410 TO 414 D-LOK MODELS

MANUFACTURER'S STATEMENTS OF SIMILARITY

Lifesaving Systems Corp.

#410 D-LOK Bill of Materials

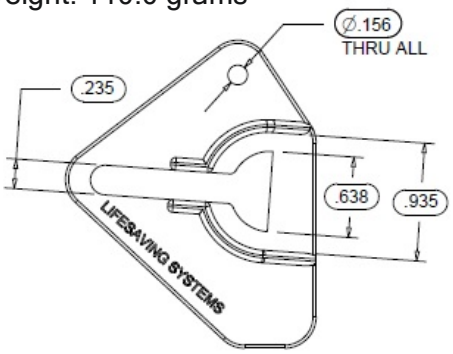
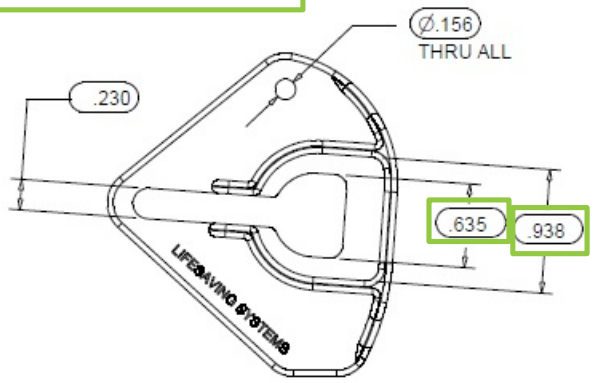
First table lists components used in top level assembly of current 410-A rescue hook. Highlighted green column represents the current latch gate assembly part number and revision.

Second table represents a list of components used in the sub-assembly of the highlighted latch gate assembly. Highlighted green columns represent the gate and latch part number with current revision.

#414 D-LOK Bill of Materials

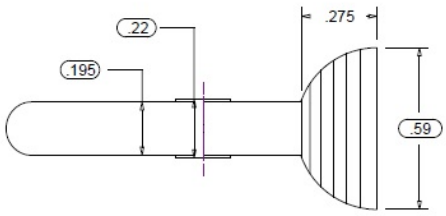
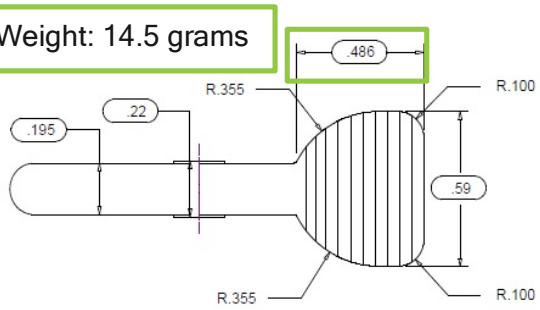
First table lists components used in top level assembly of new 414-A rescue hook. Highlighted green column represents the new latch gate assembly part number and revision.

Second table represents a list of components used in the sub-assembly of the highlighted latch gate assembly. Highlighted green columns represent the new gate and latch part number with revision.
